Intel® Pentium® 4 Processor on 90 nm Process

Specification Update

March 2006

Document Number: 302352-027

Figure 3. Intel® Pentium® 4 Processors 571, 561, 551, 541, 531 and 521^A Supporting Hyper-Threading Technology on 90 nm Process in the 775-Land LGA Package

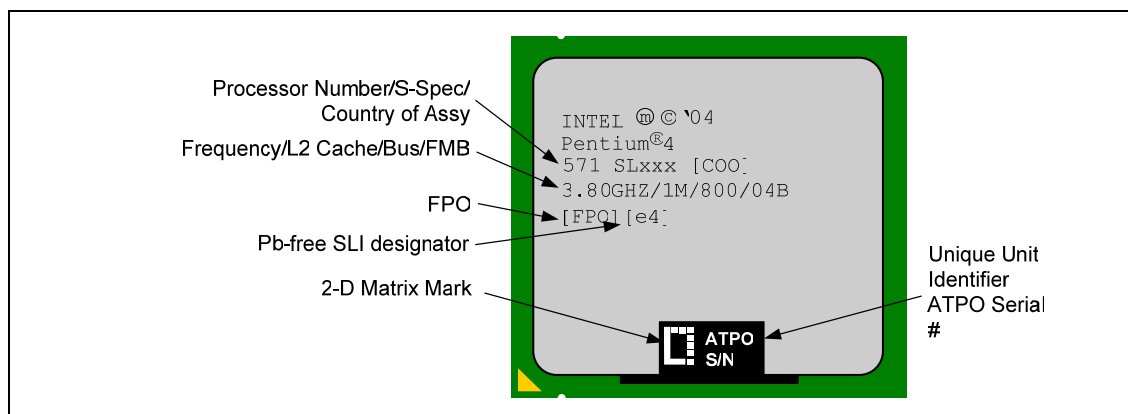
| Revision Number | Description | Date |
|-----------------|---|-------------------------------------|
| -025 | <ul style="list-style-type: none"> Updated erratum R17 and added errata R111-R114, updated processor identification table, updated figure 3 and figure 4 to show Pb-free marking | January 2006 |
